Docket Number:	12-AFC-03
Project Title:	Redondo Beach Energy Project
TN #:	205097
Document Title:	Applicant's Comments on the Preliminary Staff Assessment " Visual Resource Assessment
Description:	N/A
Filer:	Cindy Salazar
Organization:	CH2M HILL
Submitter Role:	Applicant Consultant
Submission Date:	6/19/2015 2:05:03 PM
Docketed Date:	6/19/2015

Subject: Redondo Beach Energy Project (12-AFC-03)
Applicant's Comments on the Preliminary Staff Assessment – Visual Resource Assessment

Applicant's Comments on the Preliminary Staff Assessment

FIGURE PSA-VIS-1
Aesthetic Treatment Plan –
Conceptual Plan View
 AES Redondo Beach Energy Project – PSA Comments
 Redondo Beach, California

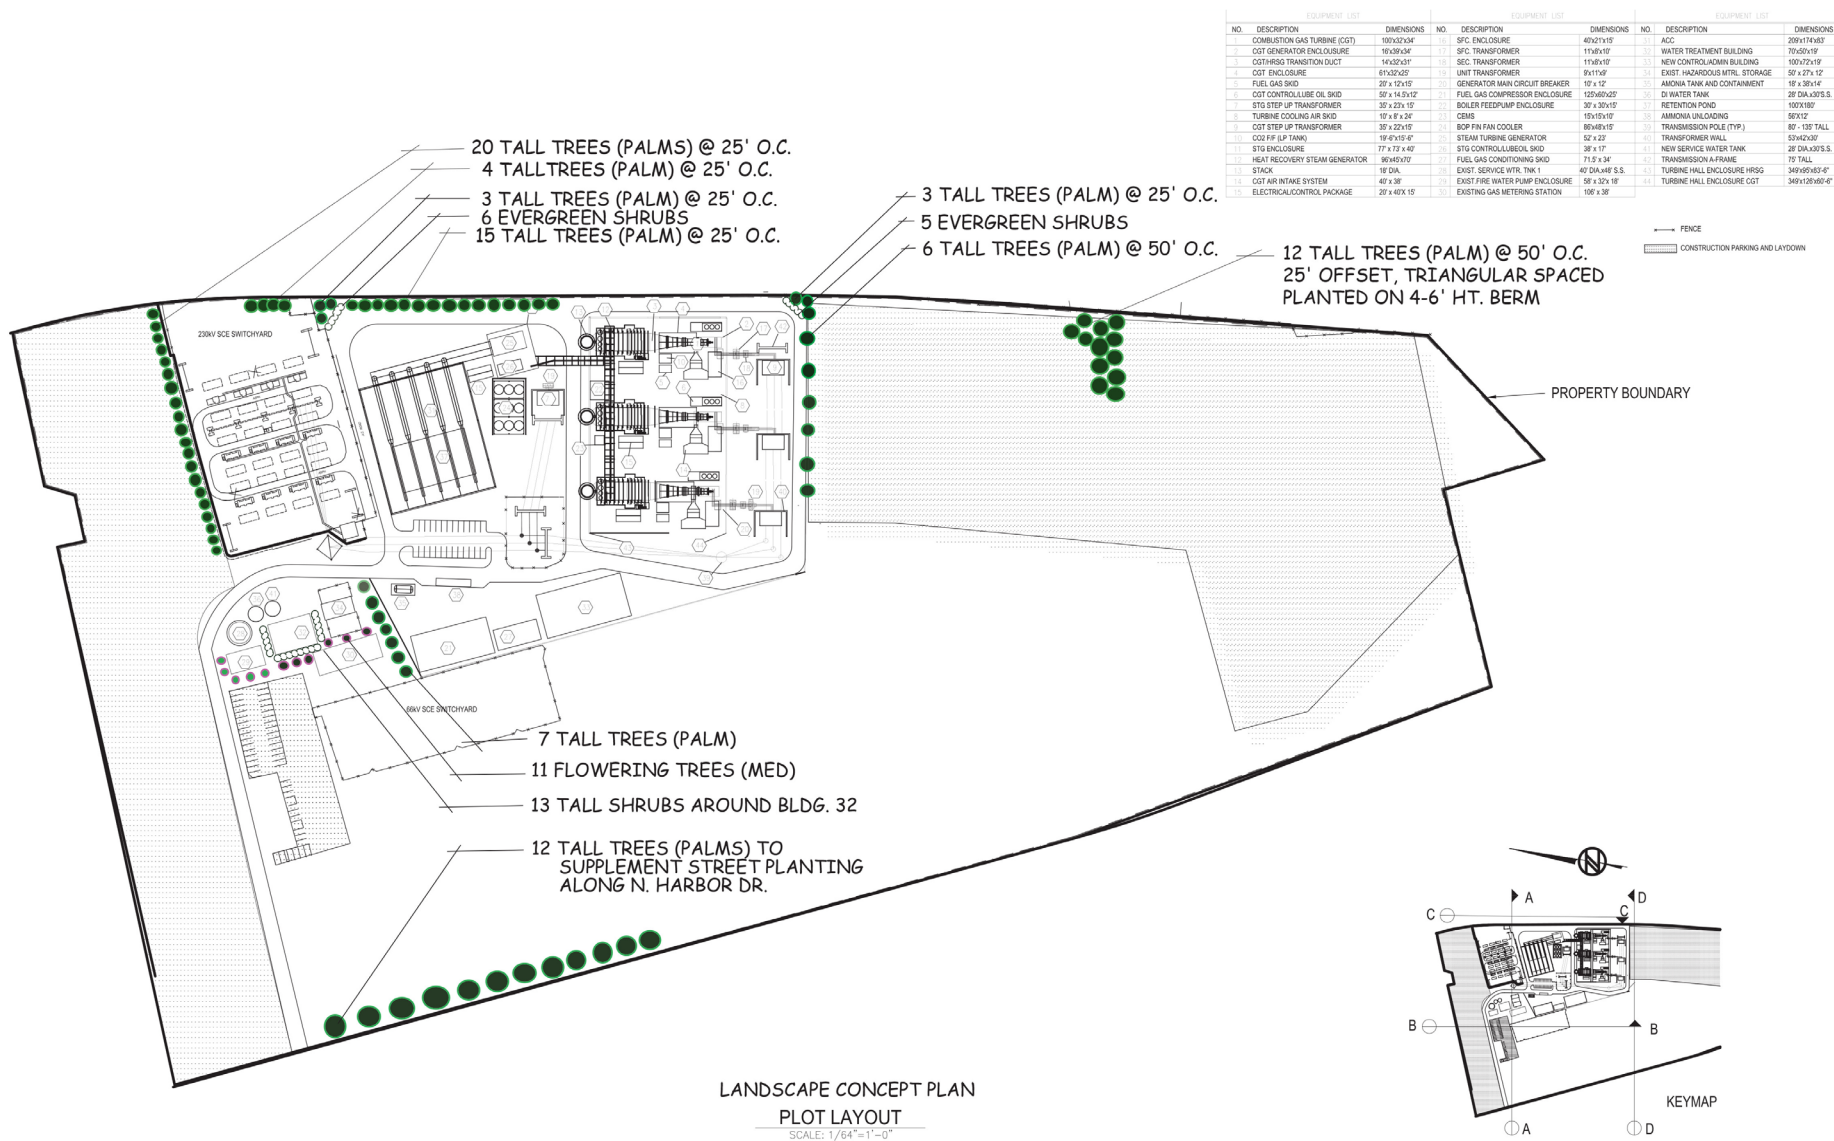
Figure PSA-VIS-1 shows the enhanced landscape concept component of the Aesthetic Treatment Plan, and Figure PSA-VIS-2 shows the conceptual landscaping on an aerial base. The conceptual color treatment component is shown in the revised simulations for views from KOP 5, KOP 8 and KOP 9. In the revised view from KOP 5 (Figure PSA-VIS-3), additional landscaping and applied color treatments are visible in the simulated (B) view. Figure PSA-VIS-4 shows an expanded, panoramic view from KOP 5, which indicates the broader positive effects on views in the vicinity with the removal of RBGS. The updated existing view from KOP 8 (the A image in Figure PSA-VIS-5) reflects recent commercial development activities along Catalina Avenue, which include a screen that obscures a lower portion of the RBEP in the simulated (B) view. In the revised view from KOP 9 (Figure PSA-VIS-6), the conceptual color treatment as simulated relates to other visible buildings and the lower portions of turbine enclosures are partially screened by the enhanced landscaping.

- Adds vegetation within the project site boundary along the northern edge of the switchyard near Herondo Street, east of the power block and air-cooled condenser (ACC), and in the southeastern portion of the project site, adjacent to the Information Technology Center surface parking area; these additions are intended to enhance screening of portions of the project as visible from the north, east and south.
- Incorporates the orange and tan color tones, found on existing building exteriors in the adjacent harbor and commercial areas, into the power block enclosures, ACC, and other visible features, with the exception of the HRSG stacks.
